# PLANNING AND ZONING CASE CHECKLIST

P&Z CASE # SP2019-043 P&Z DATE 12/30/19 CC DATE \_\_\_\_\_ APPROVED/DENIED \_\_\_\_\_  
ARCHITECTURAL REVIEW BOARD DATE \_\_\_\_\_ HPAB DATE \_\_\_\_\_ PARK BOARD DATE \_\_\_\_\_

Date: 2019-12-13 Job Number: 2019-001  
 Project Name: Ranch Trail Office Park  
 Project Submittal: Amended Site Plan – SP2019-043  
 To: Korey Brooks  
Senior Planner  
City of Rockwall  
385 S. Goliad Street, 75087  
972.772.6434

Re: Ranch Trail Office Park– Amended Site Plan - SP2019-043

SHEET  
**L-1**

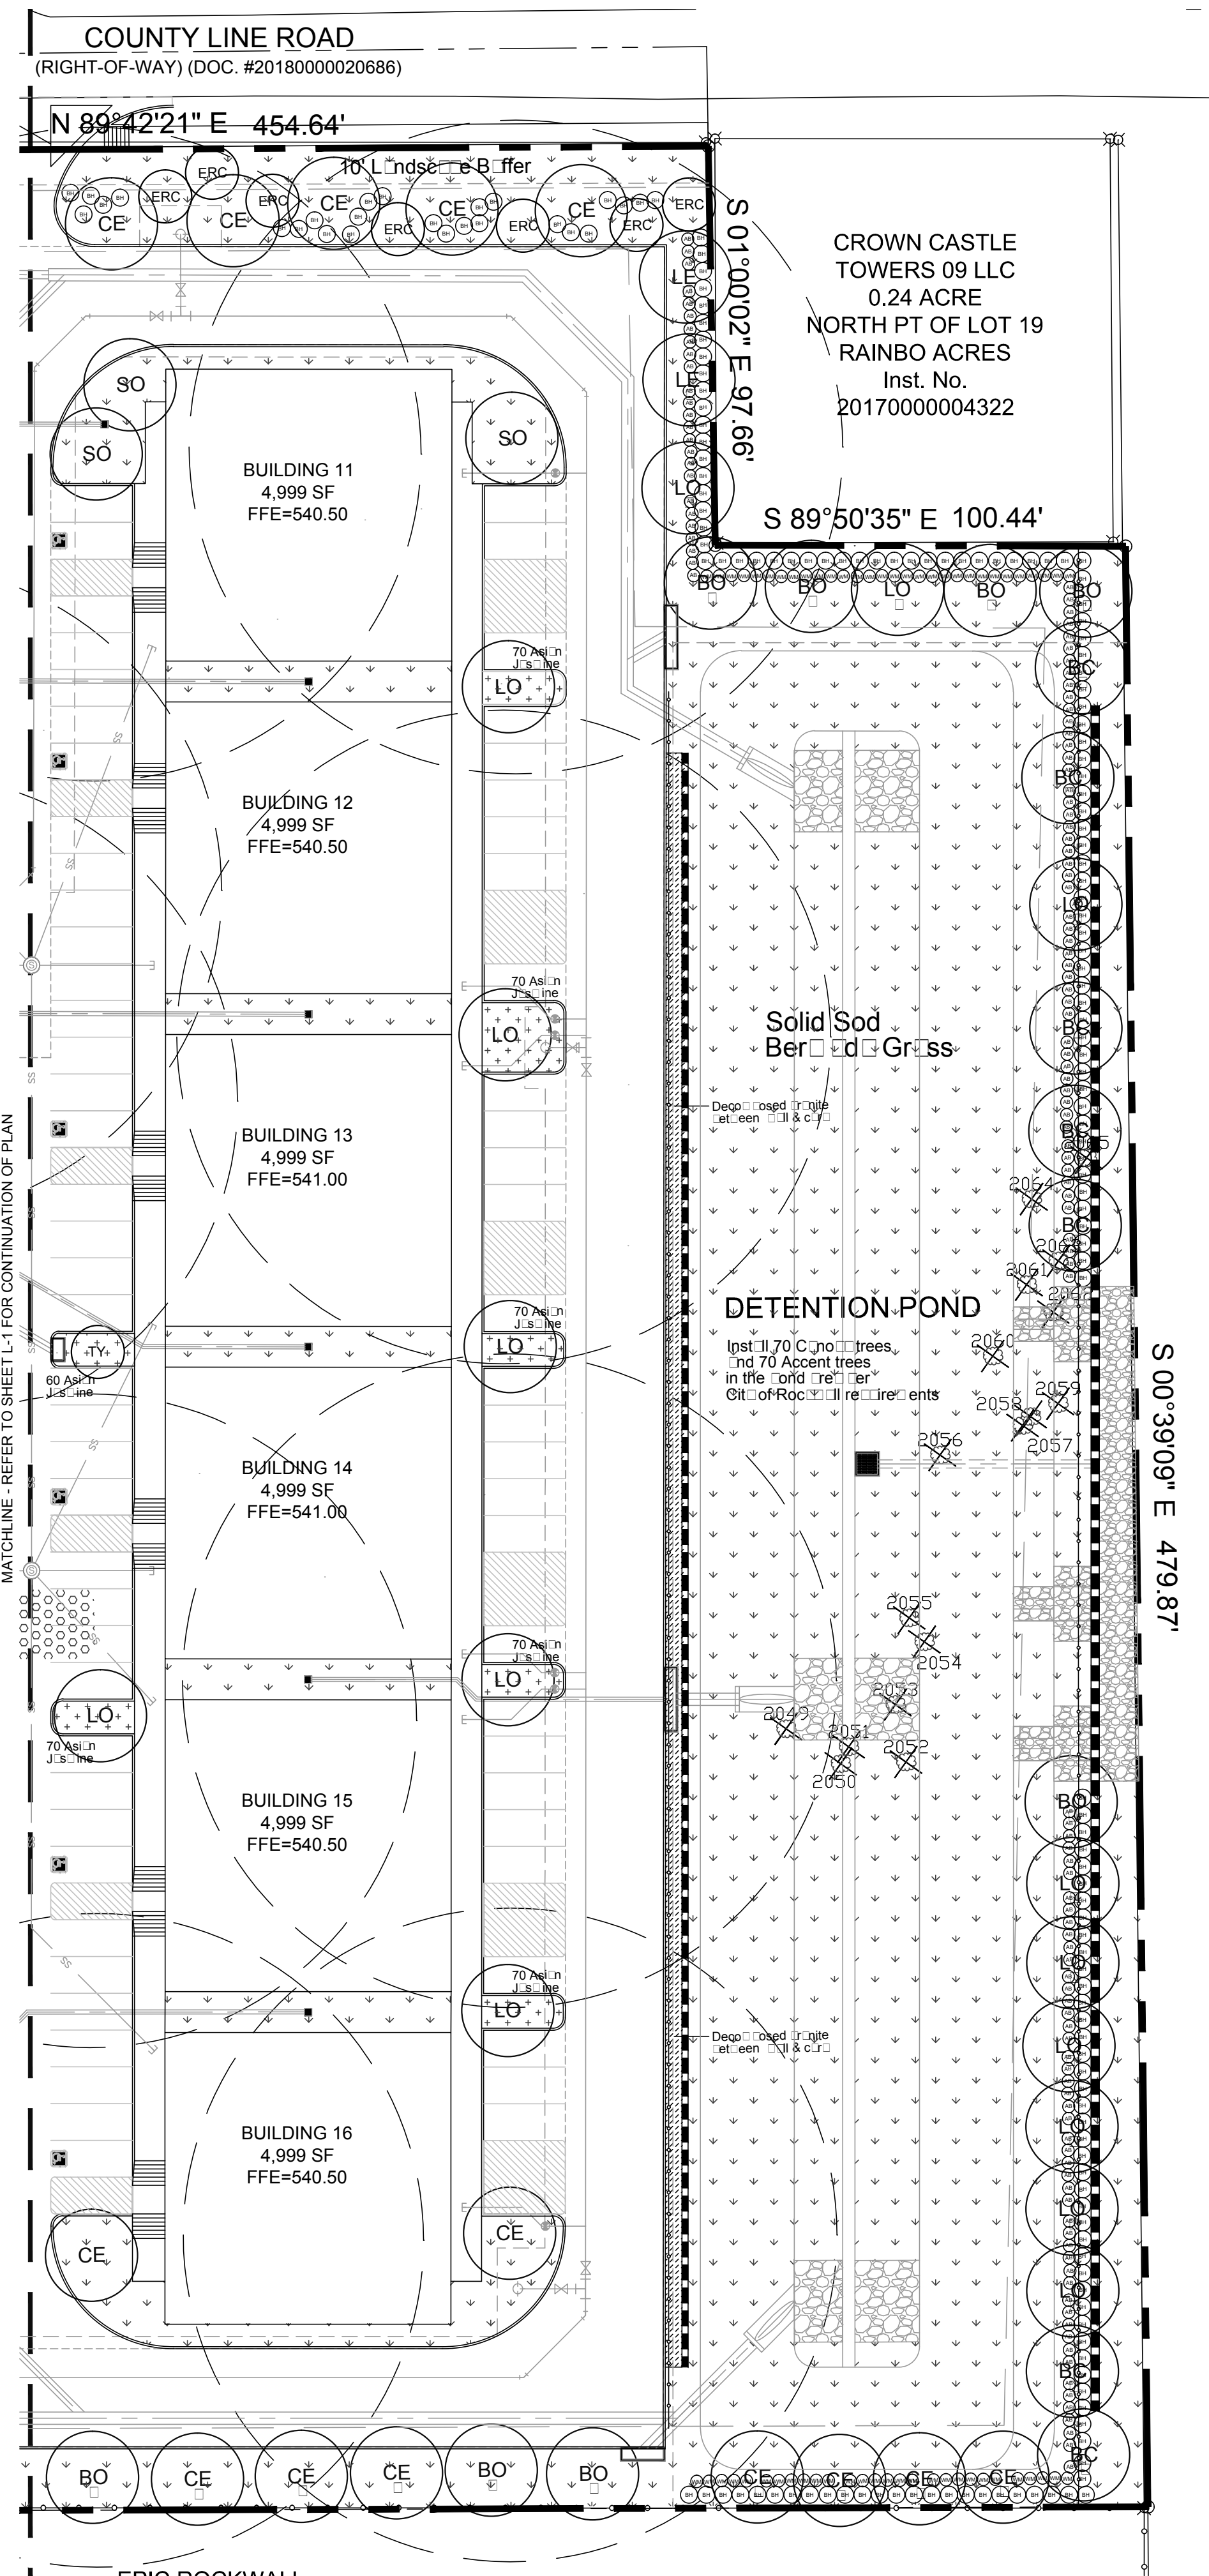
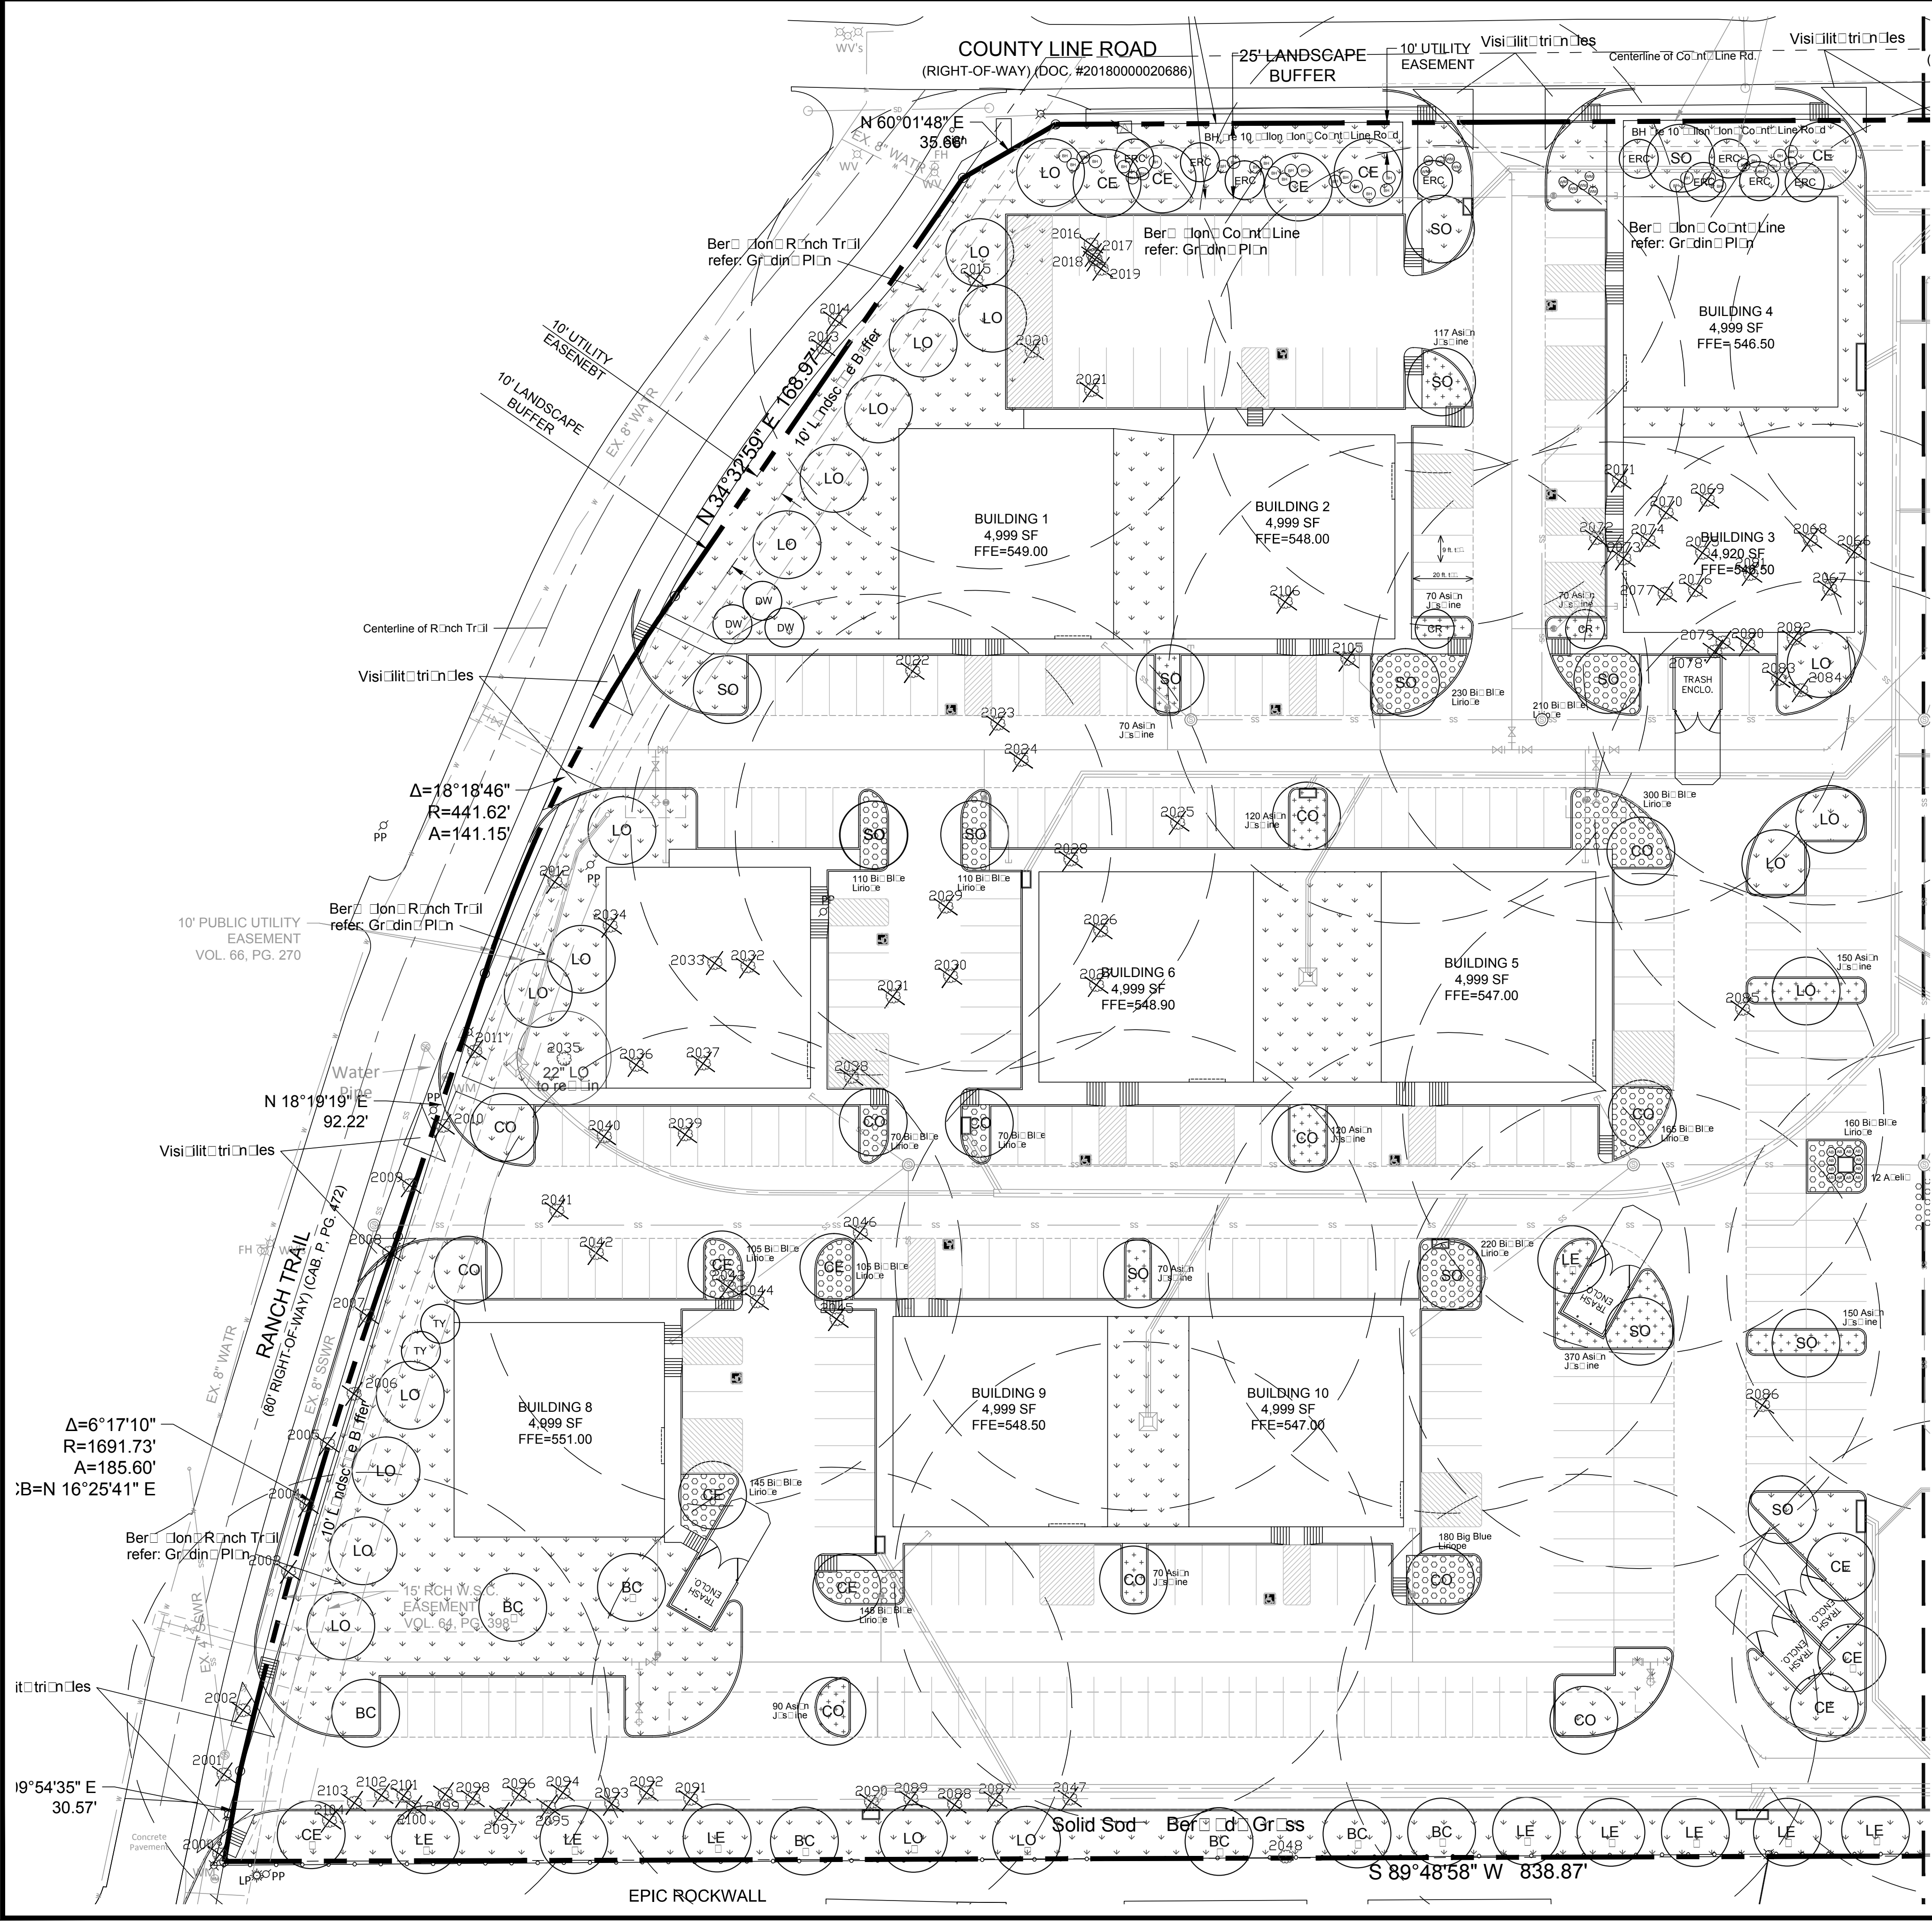
***THIS COMMENT HAS ALREADY BEEN DISCUSSED AND ACCEPTED BY THE CITY.***
17. Site Plan. Please note our updated screening requirements for residential adjacency.

may approve an alternative screening method that incorporates a wrought iron fence and three (3) tiered screening (i.e. [1] small to mid-sized shrubs, large shrubs or accent trees, and canopy trees or [2] evergreen trees and canopy trees) along the entire length of the adjacency (as depicted in Figure 8, 9, & 10 below). The canopy trees shall be placed on 20-foot centers.

***LANDSCAPE PLANS HAVE BEEN REVISED. 3-TIER SCREENING HAVE BEEN PROVIDED ALONG PROPERTY LINES.***

***LANDSCAPE PLANS HAVE BEEN REVISED. CANOPY TREES HAVE BEEN PROVIDED.***
